A. ADMINISTRATIVE REPORT & DECISION

Project Name: New Cingular Wireless PCS, LLC (AT&T) Stealth Tower

File Number: LUA16-000861, CU-A

Project Summary: New Cingular Wireless PCS, LLC is requesting approval of an Administrative Conditional Use Permit for the installation of a new 59 foot 10 inch tall Stealth Tower designed to imitate the physical characteristics of a streetlight pole. The four panel antennas and associated cabling would be fully concealed in the tower. The project site has an existing multitenant retail building and an adjacent parking lot that serves businesses in the retail building. Existing wireless communication facility antennas are installed on the eastern edge of the rooftop of the one-story wood frame retail building located at 2439 Maple Valley Hwy (SR 169), the parcel adjacent to the site of the proposed tower. According to a Structural Analysis Report submitted by the applicant, the rooftop supporting the existing telecommunications equipment is insufficient for loading due to structural integrity concerns. The rooftop equipment would be completely removed after the installation of the stealth tower. No changes are proposed for the associated equipment

SHEET TITLE
SOUTH TOWER ELEVATION

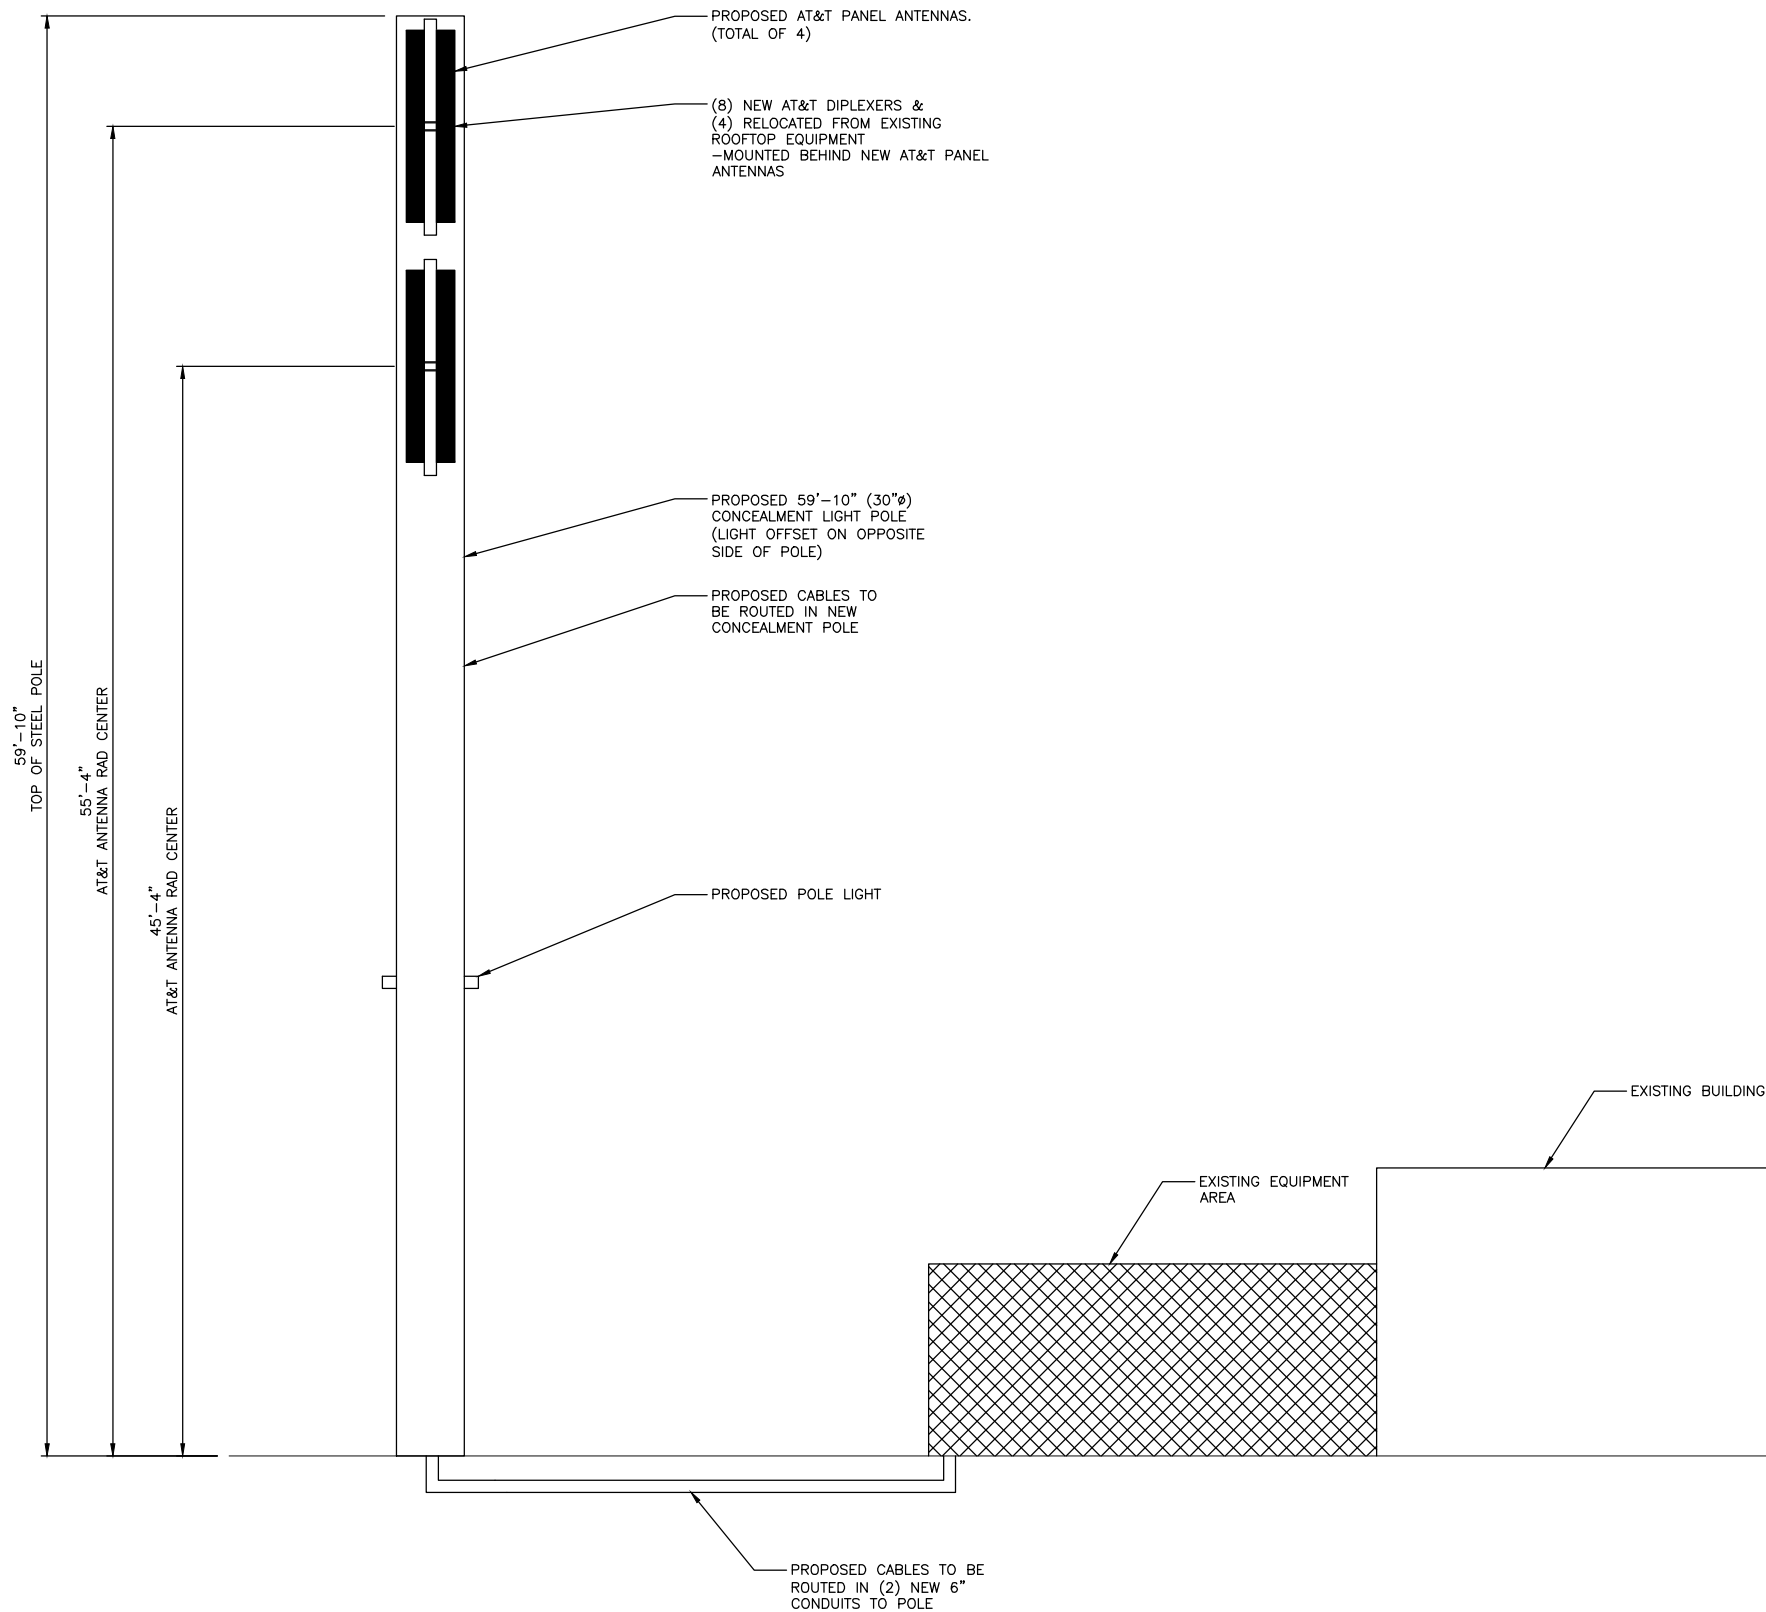
3. The tallest point of the proposed tower shall not be greater than twenty five (25) feet when measured from grade. Compliance with the height restriction shall be verified with the building permit application and approved by the Current Planning Project Manager prior to building permit issuance.

4. The design of the stealth tower shall more closely replicate a street light pole. The final design shall be reviewed and approved by the Current Planning Project Manager at the time of building permit application.

6. The stealth tower shall be painted with a non-glare, flat grey finish. The type of finish shall be identified in the building permit application for review and approval by the Current Planning Project Manager prior to building permit issuance.
